SUBJECT: ISSUANCE OF AMENDMENTS (TAC NOS. MA1937, MA1938, MA1966,  
AND MA1967)

The Commission has issued the enclosed Amendment No. 169 to Facility Operating License No. DPR-19 and Amendment No. 164 to Facility Operating License No. DPR-25 for Dresden Nuclear Power Station, Units 2 and 3, and Amendment No. 181 to Facility Operating License No. DPR-29 and Amendment No. 179 to Facility Operating License No. DPR-30 for the Quad Cities Nuclear Power Station, Units 1 and 2, respectively. The amendments are in response to your application dated May 18, 1998.

The amendments will change several Technical Specification (TS) values to reflect design values. These TS values affect (1) 125/250 volts direct current (Vdc) electrolyte temperature; (2) control rod drive accumulator pressure; (3) standby liquid control solution temperature; (4) ultimate heat sink minimum water level; (5) shutdown suppression chamber level (Quad Cities only); and (6) a degraded voltage setpoint (Quad Cities only).

Dresden Nuclear Power Station  
Units 2 and 3  
Quad Cities Nuclear Power Station  
Units 1 and 2

#### C. TS Figure 3.4.A-1, Sodium Pentaborate Solution Temperature Requirements

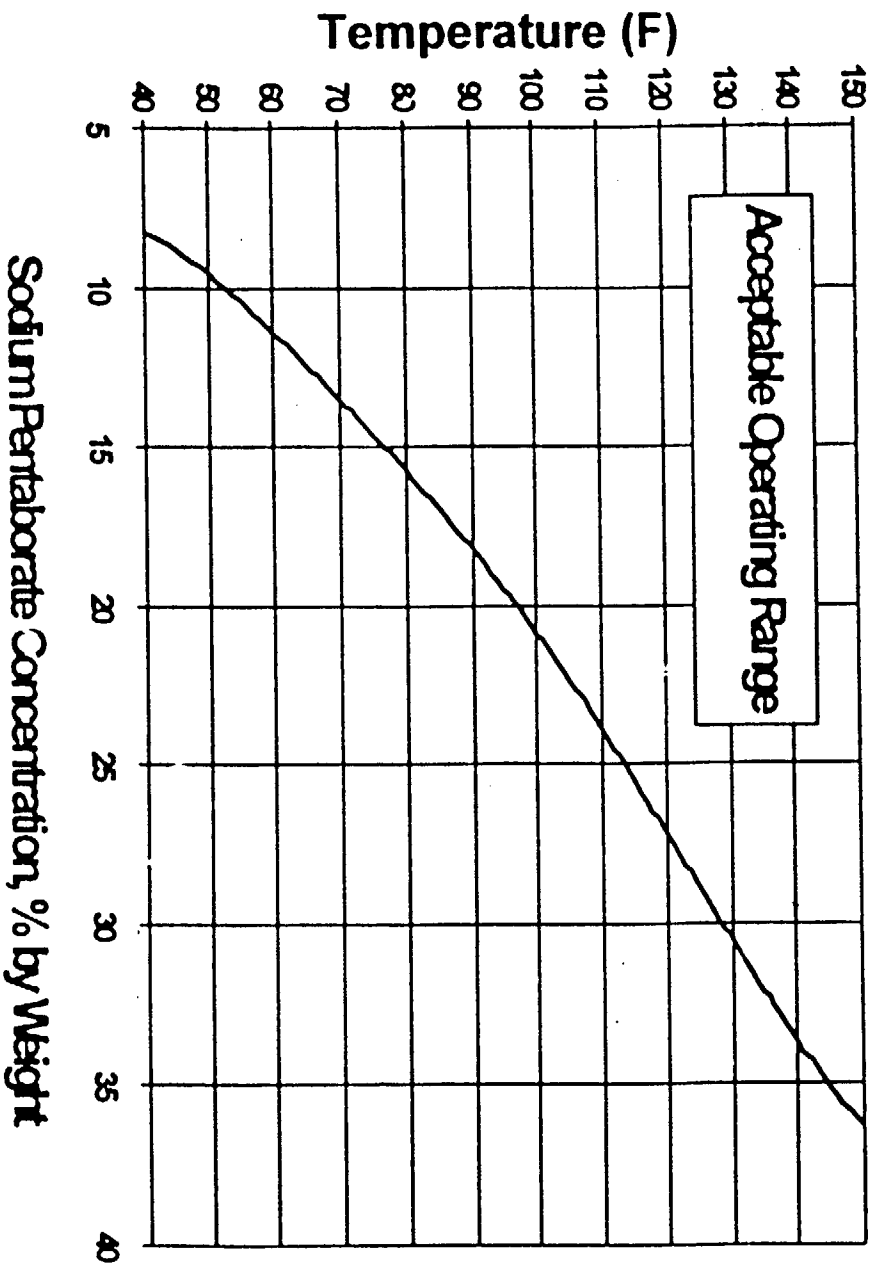
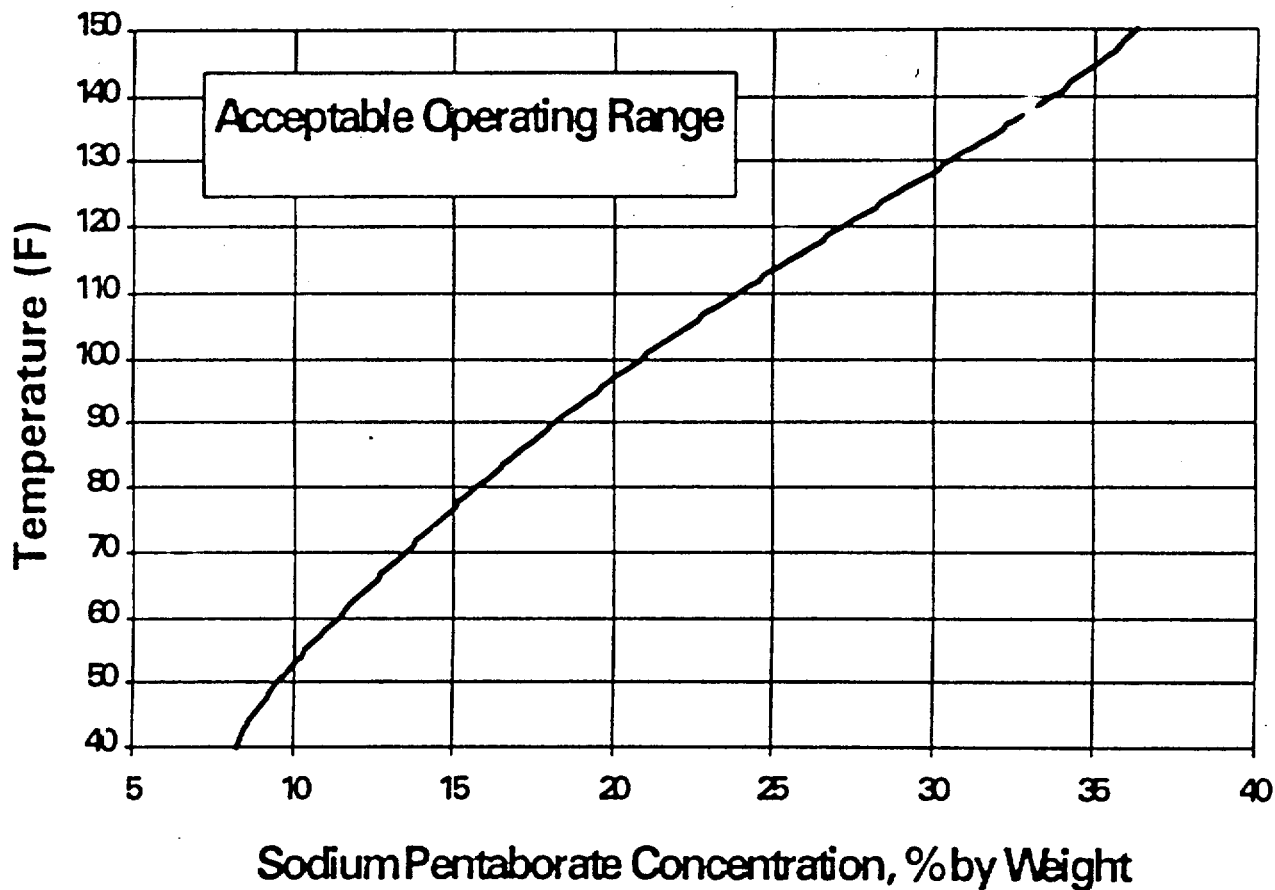
ComEd had determined that the minimum temperature limit specified in the current TS Figure 3.4.A-1 for Dresden and Quad Cities does not ensure a 10 degrees Fahrenheit margin to the solubility temperature for an aqueous solution of sodium pentaborate.

The use of the solubility curve as protection against precipitation is conservative as follows. The solubility curve assures that for a given concentration and temperature, the solute will stay dissolved in the solvent. This is because the precipitation of sodium pentaborate involves an endothermic chemical reaction; therefore, the temperature of precipitation will occur at a lower temperature than the solubility temperature. The TS provide additional margin by maintaining the

sodium pentaborate solution 10 degrees Fahrenheit above the saturation temperature. For these reasons, the proposed TS Figure 3.4.A-1, restores the 10 degrees Fahrenheit margin from the theoretical solubility curve for sodium pentaborate which is based on sodium pentaborate solubility temperature, is adequate to prevent boron precipitation; therefore, this change is acceptable.
